ADDENDUM NO. 2

TSA OFFICE BUILD-OUT

SYRACUSE HANCOCK INTERNATIONAL AIRPORT
SYRACUSE REGIONAL AIRPORT AUTHORITY
SYRACUSE, NEW YORK

IFB REFERENCE #2021-07

A-103

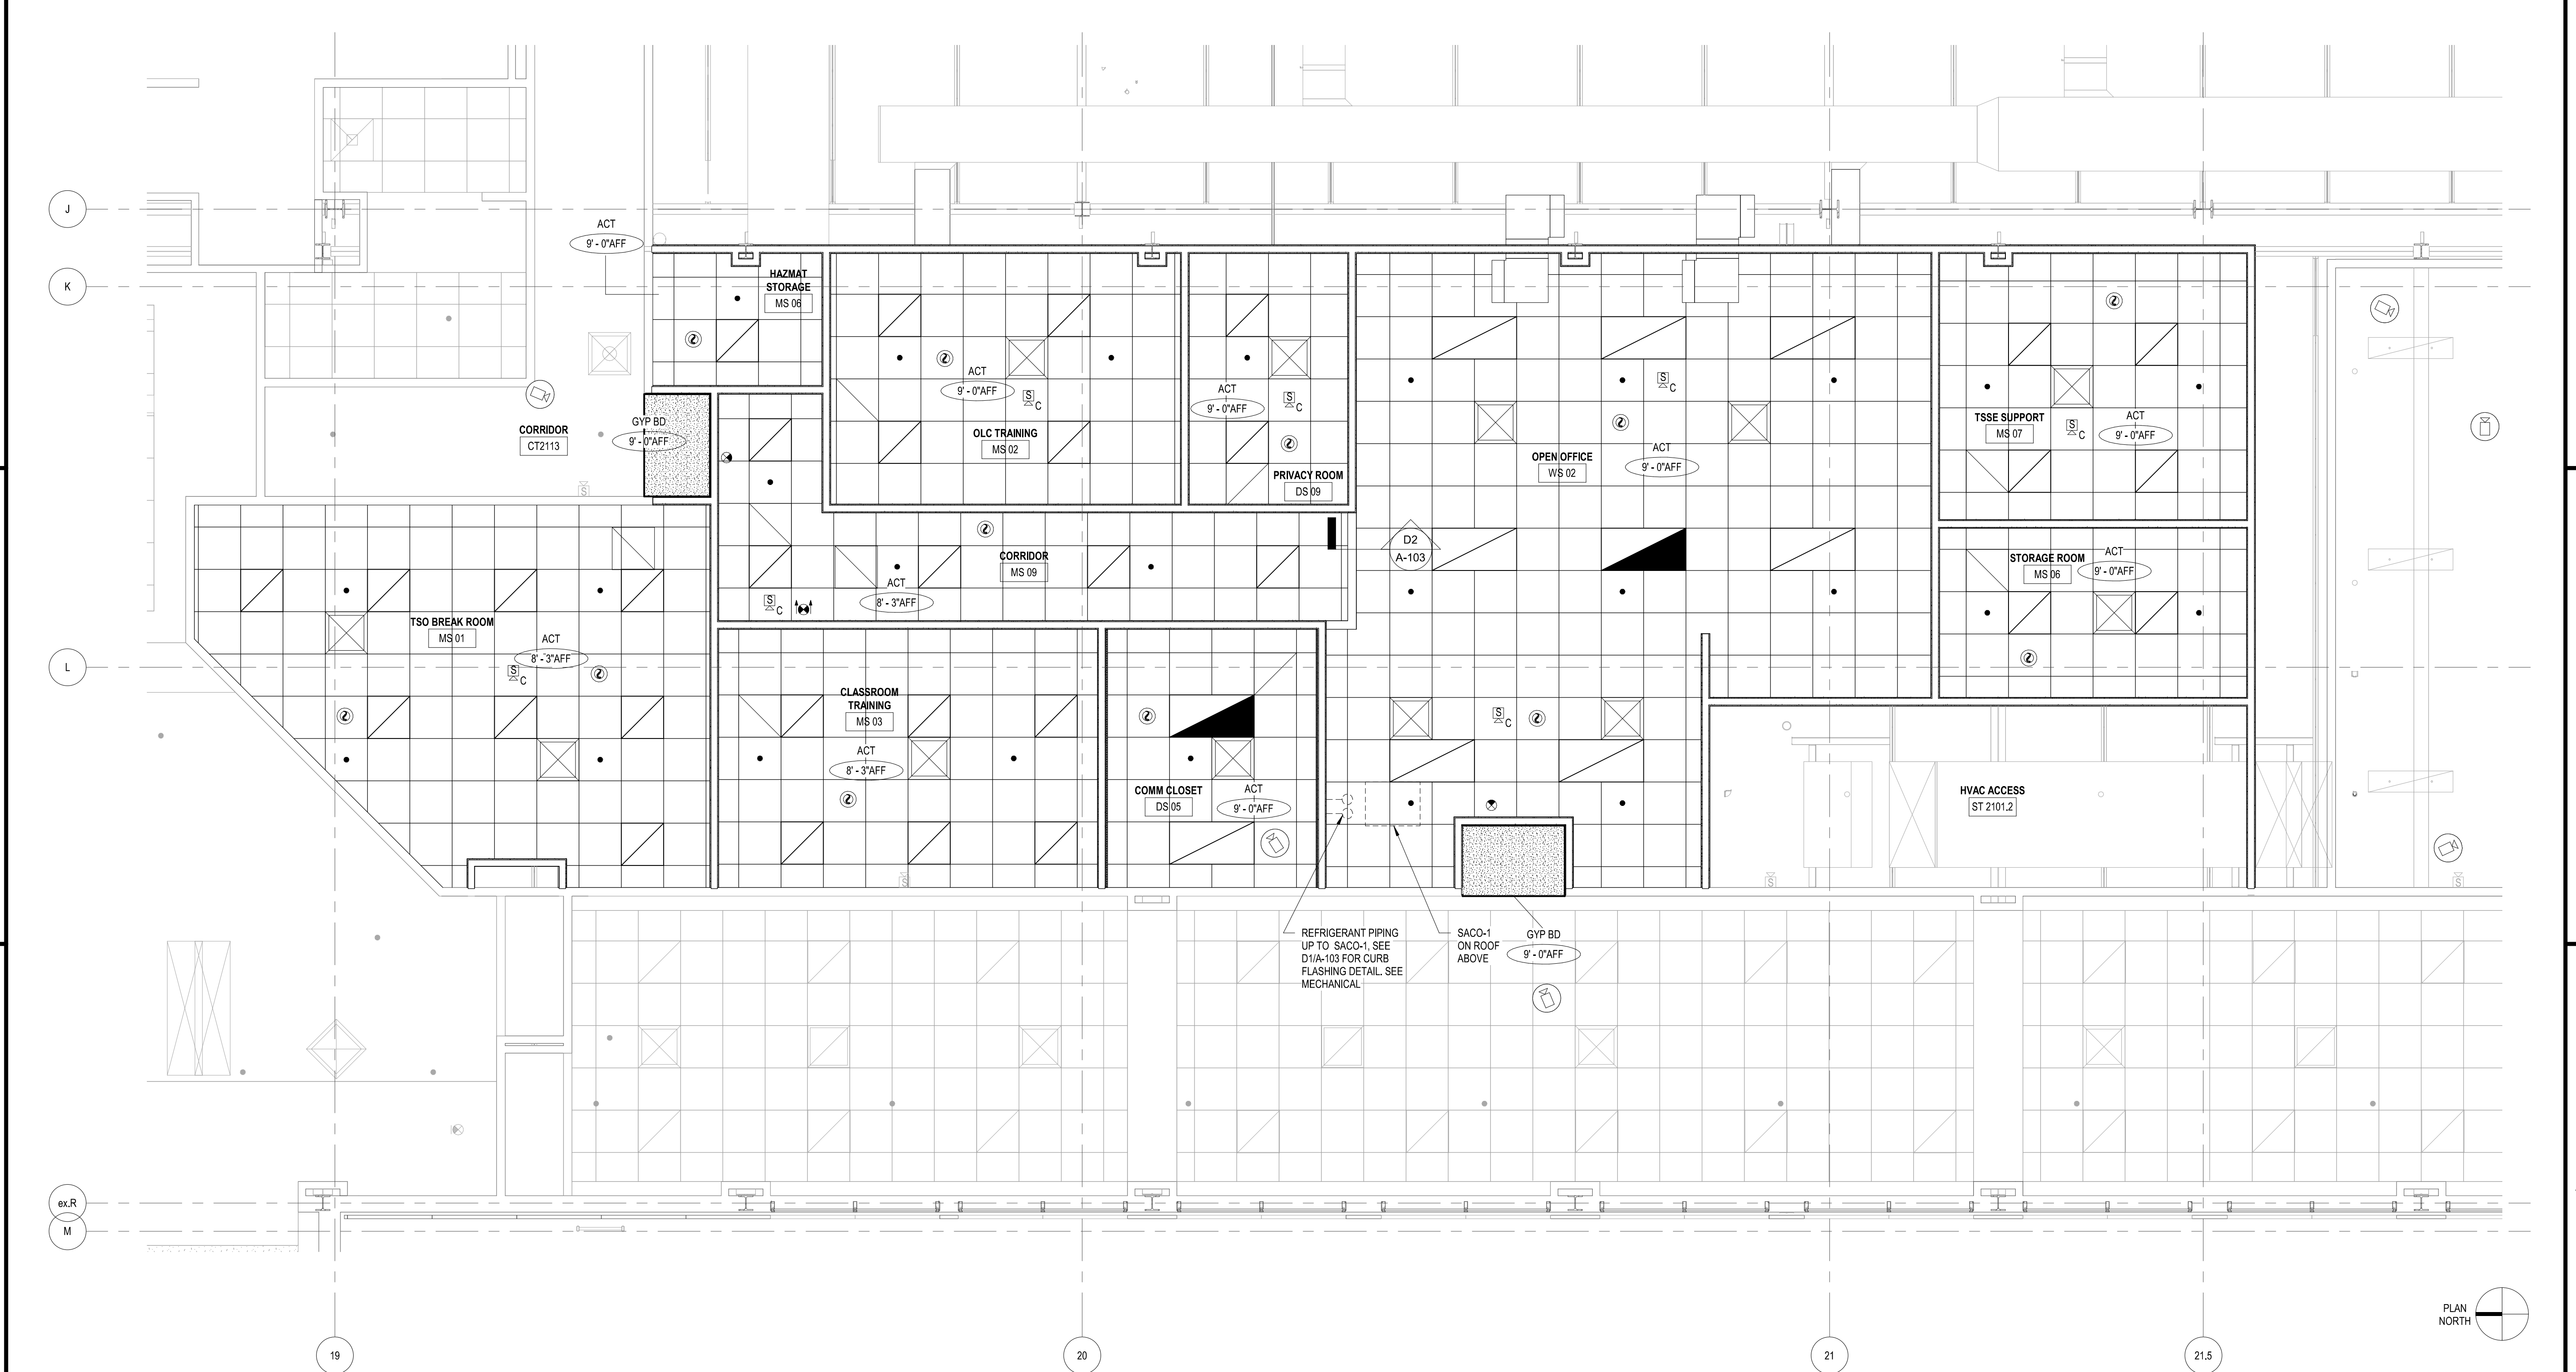
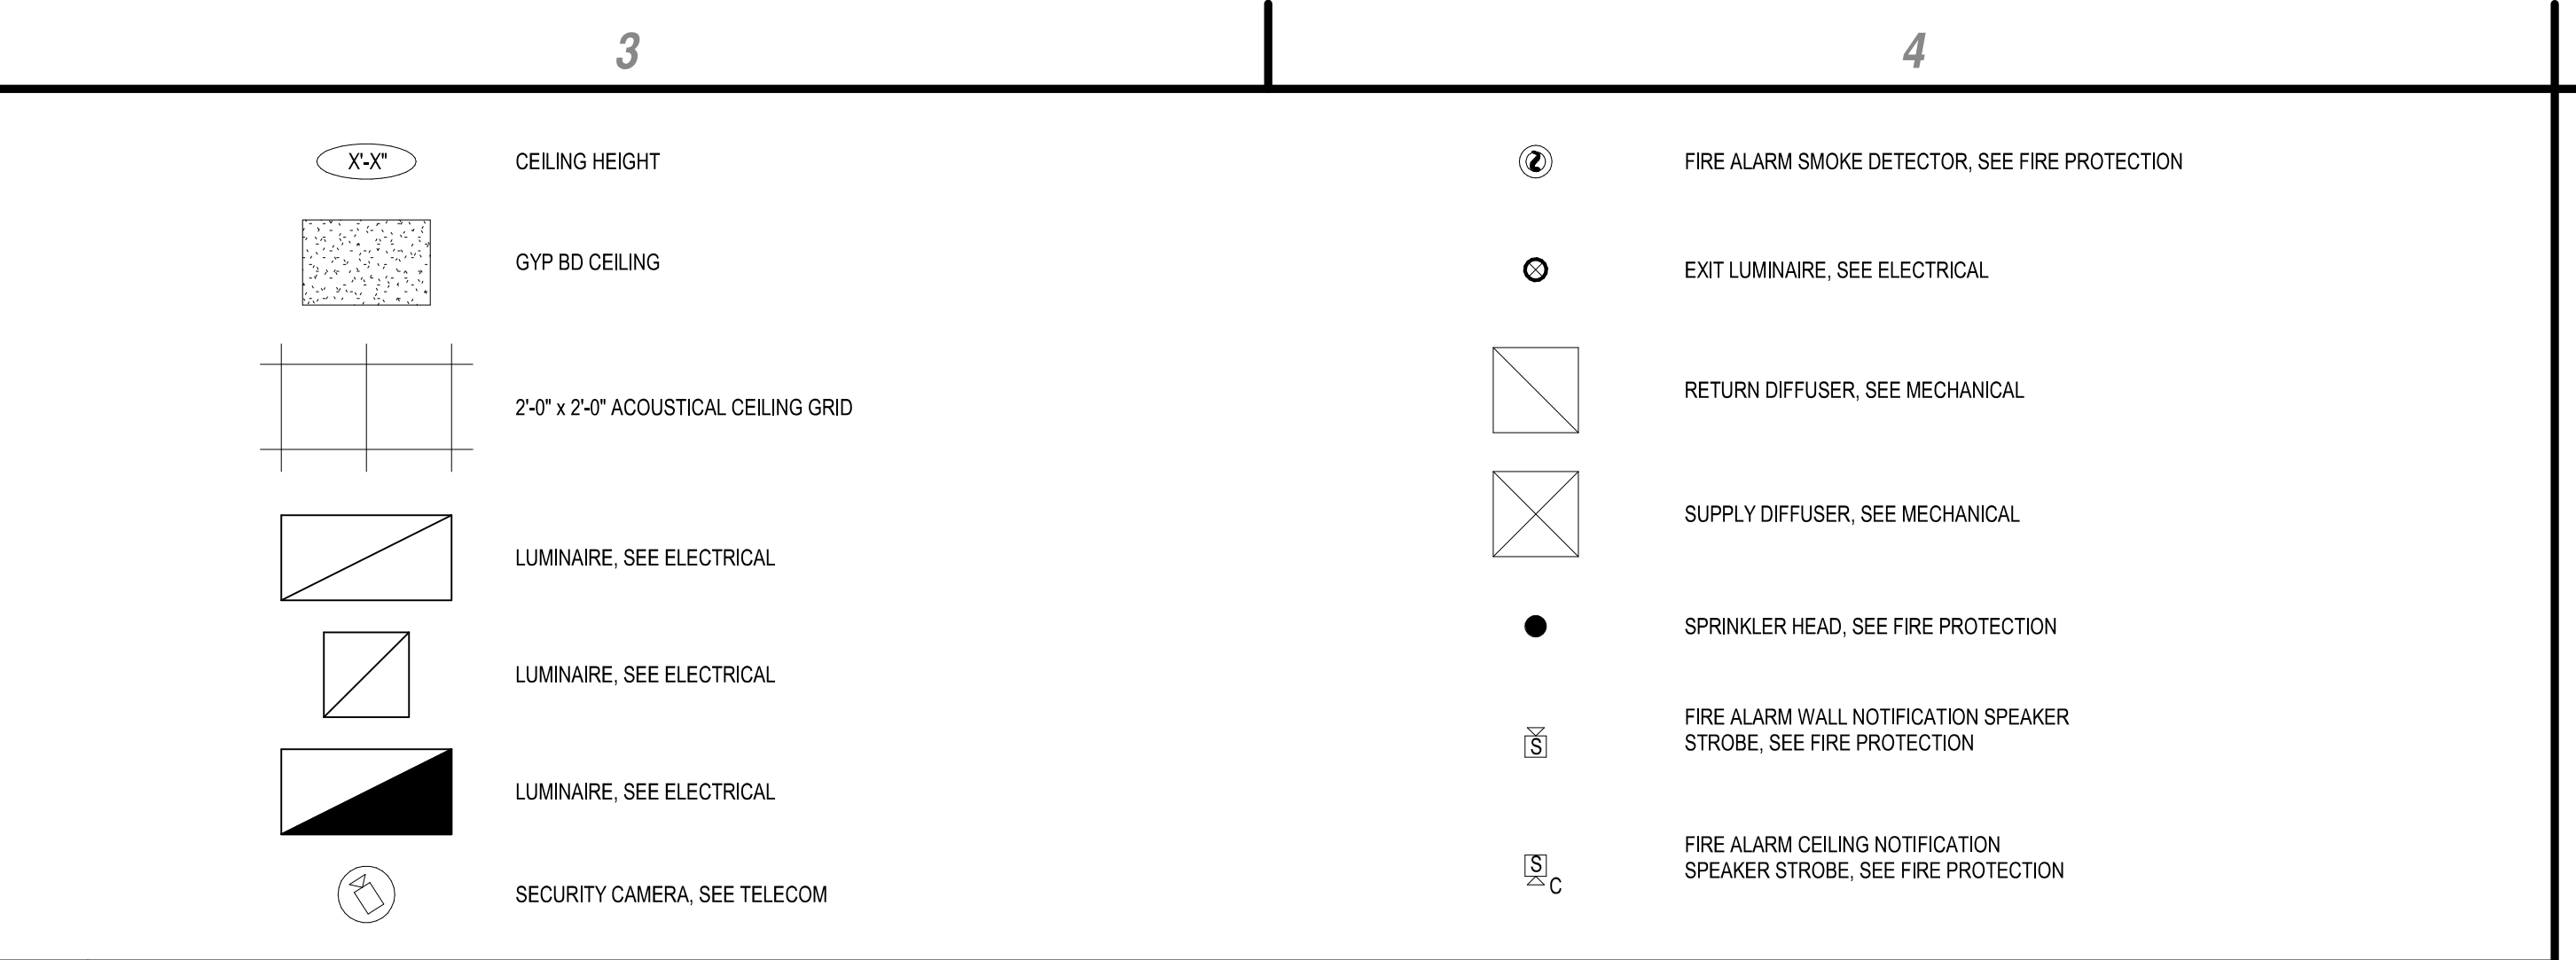
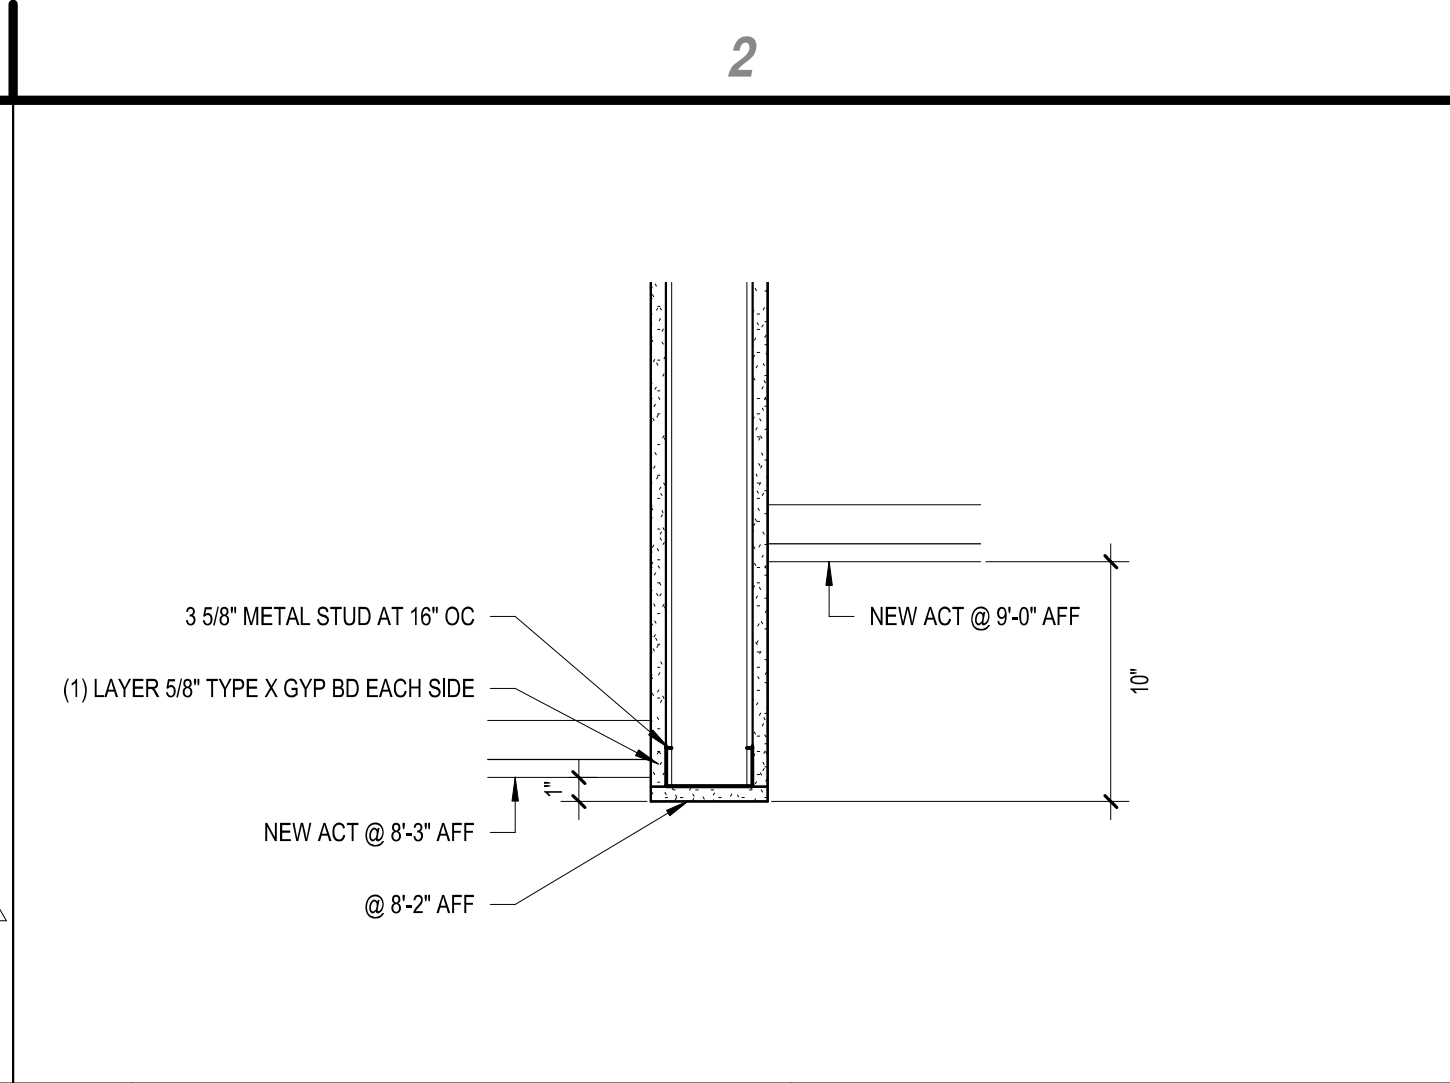
7. Sheet A-102 – Paradies Relocation Plan: **DELETE** Wall Type MA-3 call-out and **SUBSTITUTE THEREFORE** PT-3.
8. Sheet A-103 – TSA New Construction Reflected Ceiling Plan: **DELETE** in its entirety and **SUBSTITUTE THEREFORE** with attached A-103 Revision 1.
9. Sheet A-601 – Schedules: **DELETE** in its entirety and **SUBSTITUTE THEREFORE** with attached A-601 Revision 2.
10. Sheet E-102 – Electrical Plans - Proposed: **DELETE** in its entirety and **SUBSTITUTE THEREFORE** with attached E-102 Revision 2.
11. Sheet E-601 – Electrical Schedules: **DELETE** in its entirety and **SUBSTITUTE THEREFORE** with attached E-601 Revision 2.
